TOWN OF MONUMENT 2.0 MG WATER STORAGE TANK

MONUMENT COLORADO

90% SUBMITTAL

Site Development Plan _V2 combined redlines.pdf Markup Summary 1-27-2022

E01

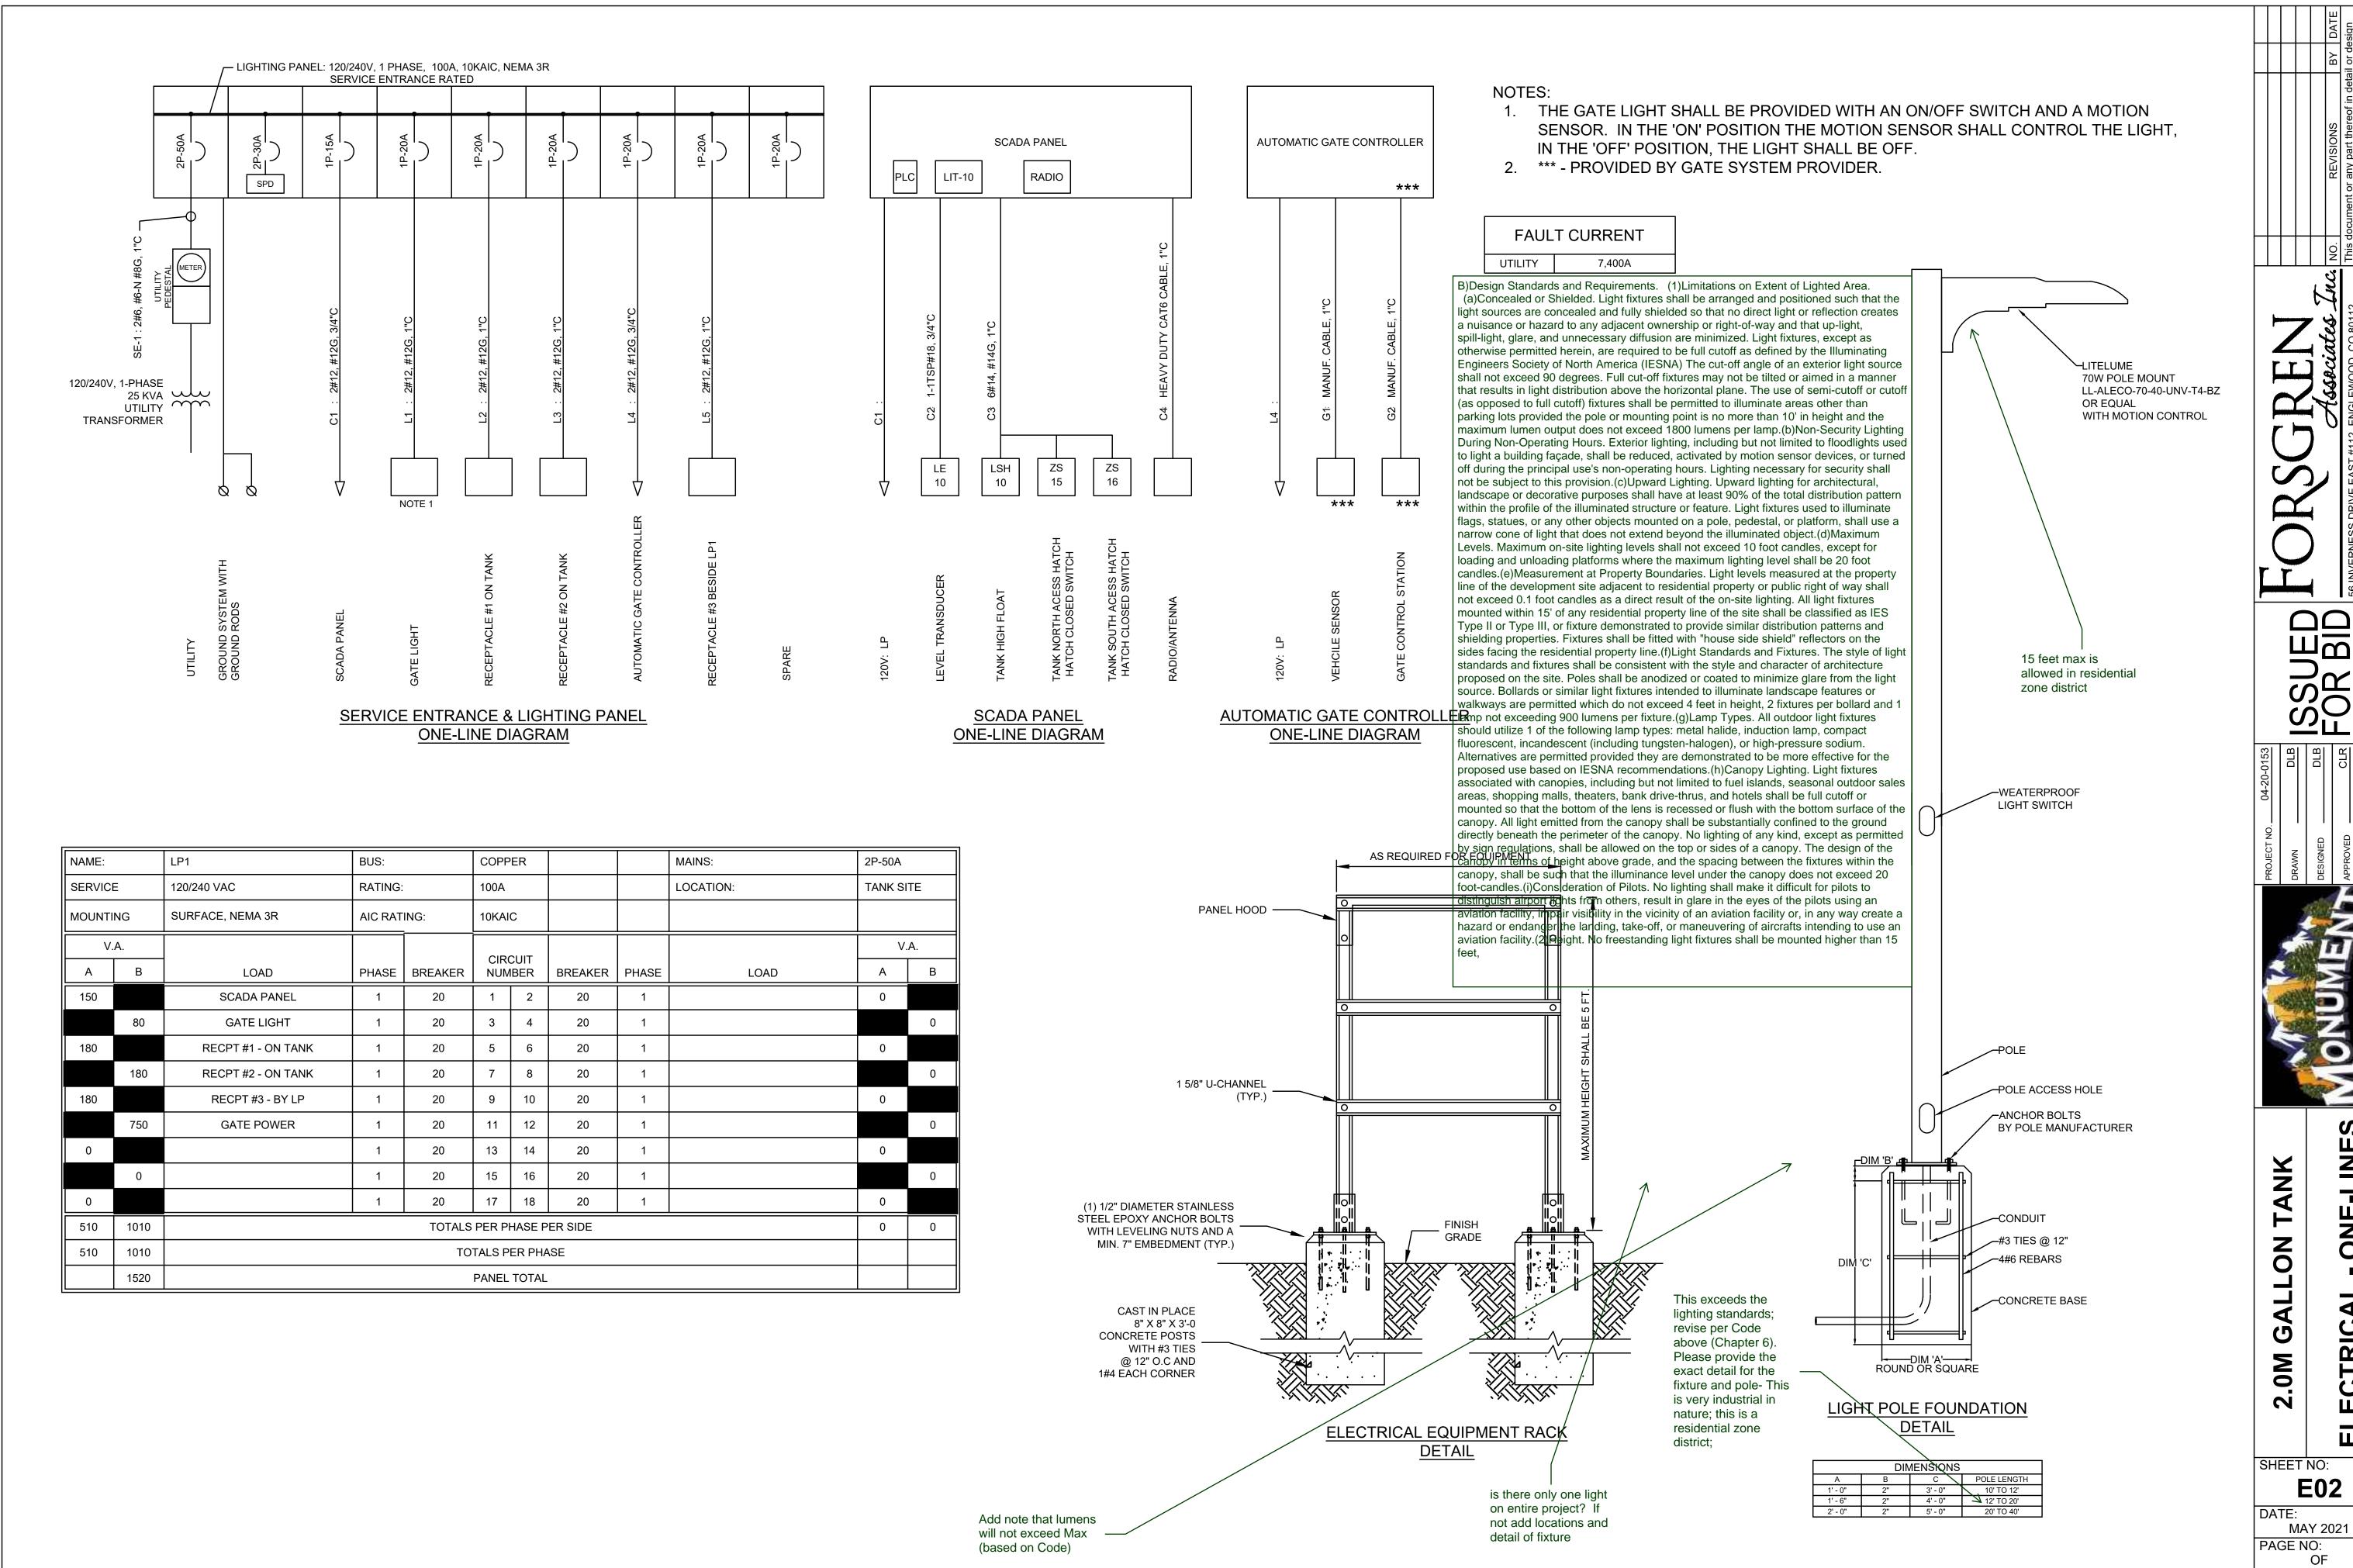
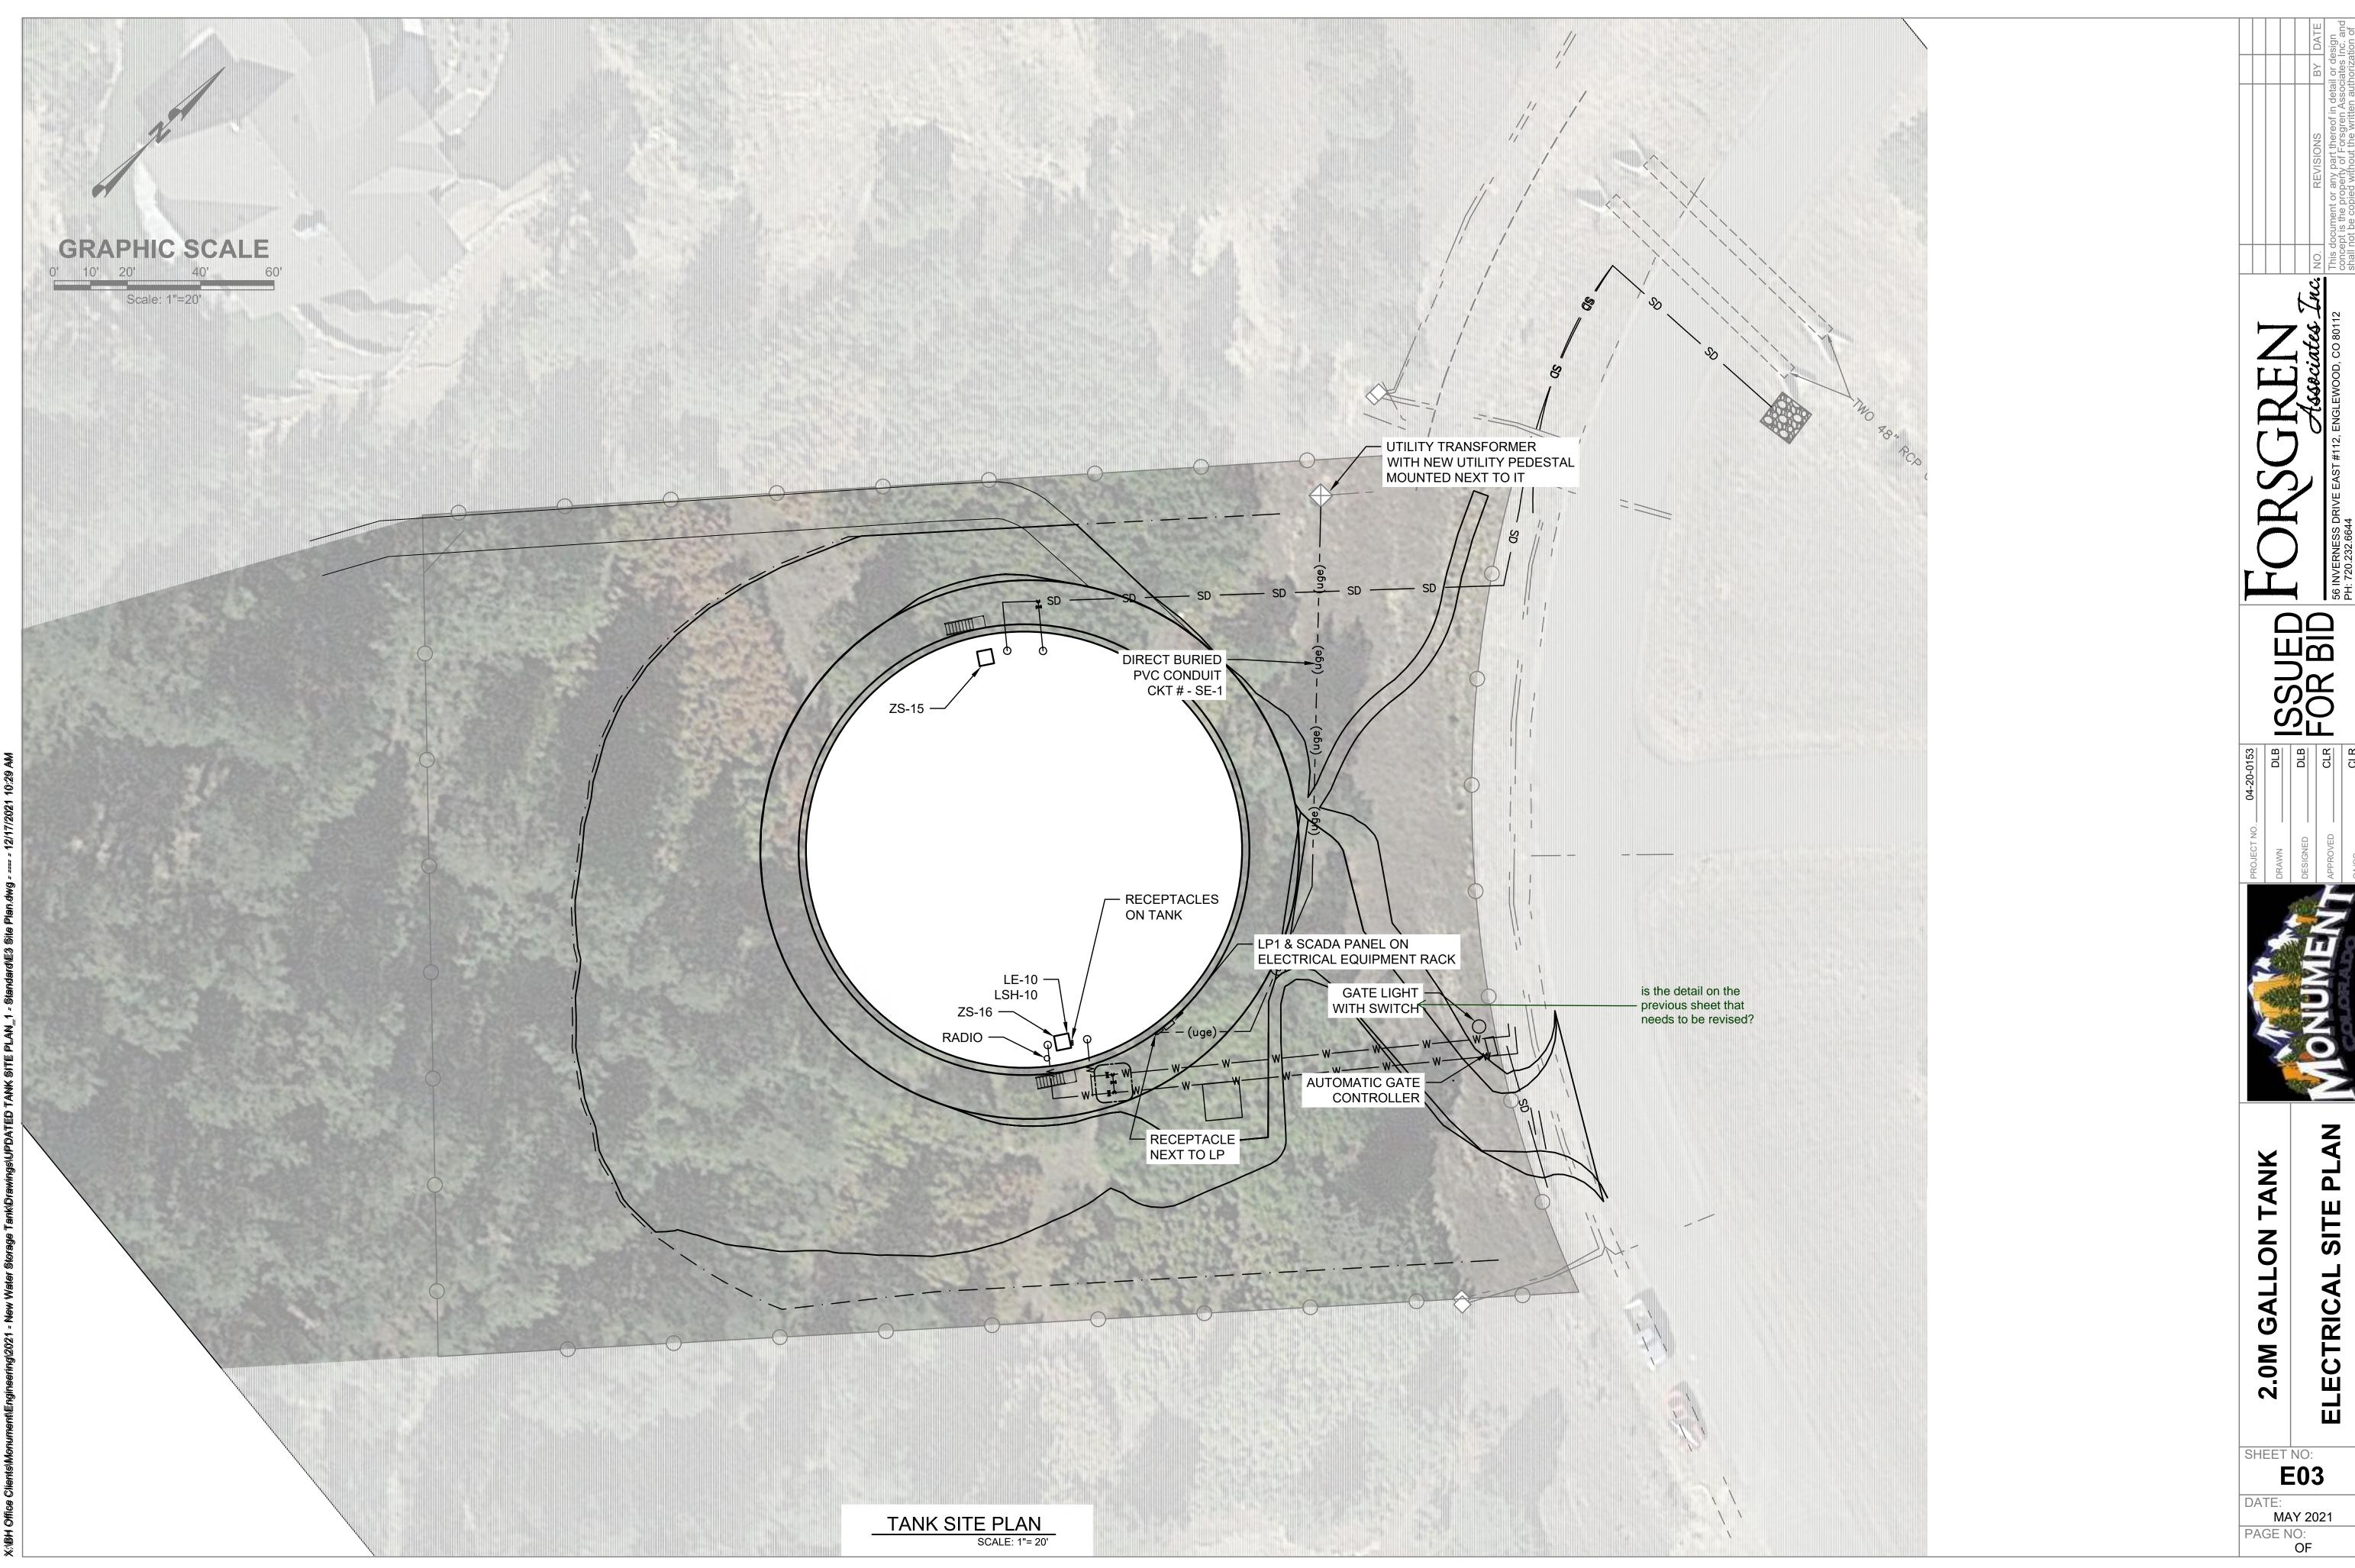
This exceeds the lighting standards; revise per Code above (Chapter 6). Please provide the exact detail for the fixture and pole- This is very industrial

in nature; this is a residential zone district;

Status: Color: ■ Layer: Space: 15 feet max is allowed in residential zone district

Status: Color: ■ Layer: Space: Add note that lumens will not exceed Max (based on Code)

Status: Color: ■ Layer: Space: is there only one light on entire project? If not add locations and detail of fixture

PROJECT LOCATION MAP

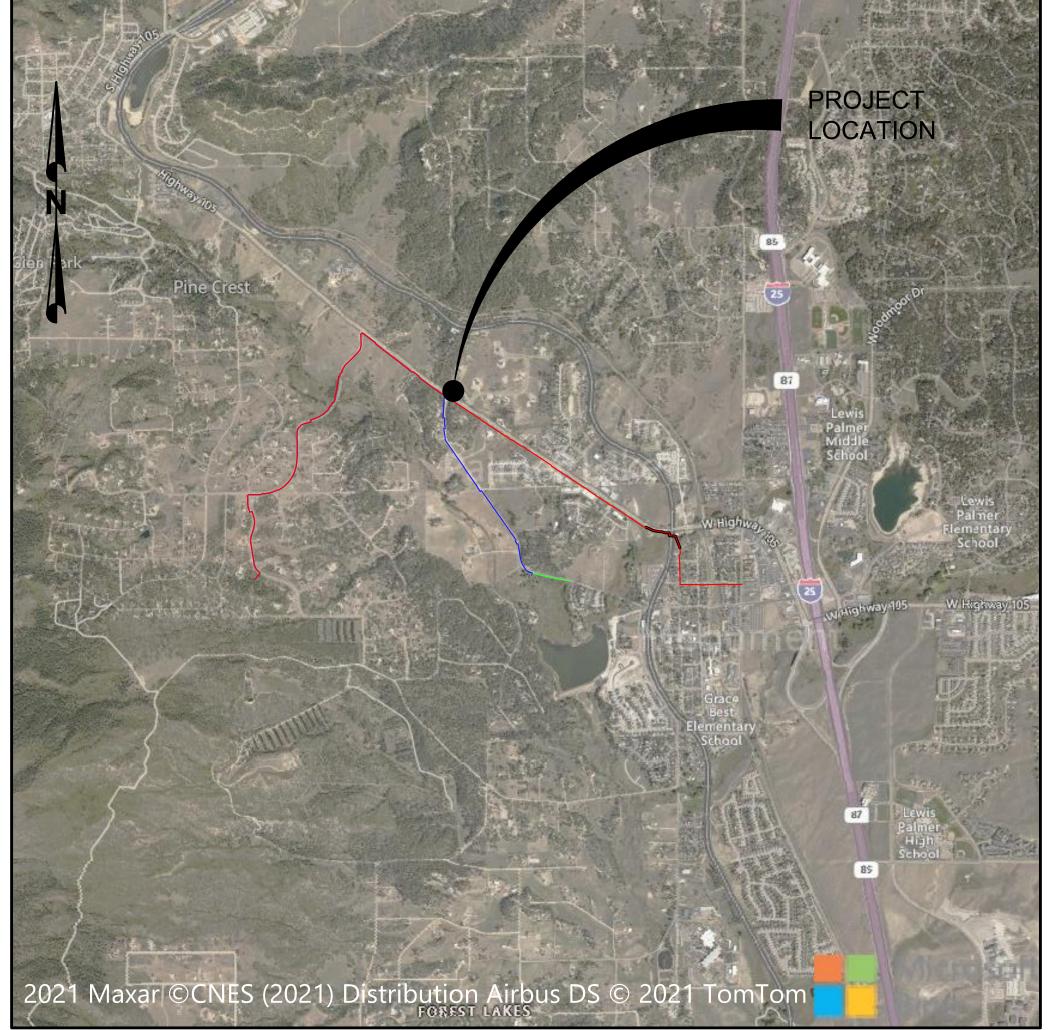
lease label "for reference only" as actual waterline

Ds will be approved separately.

Status: Color: Layer: Space: Please label "for reference only" as actual waterline CDs will be approved separately.
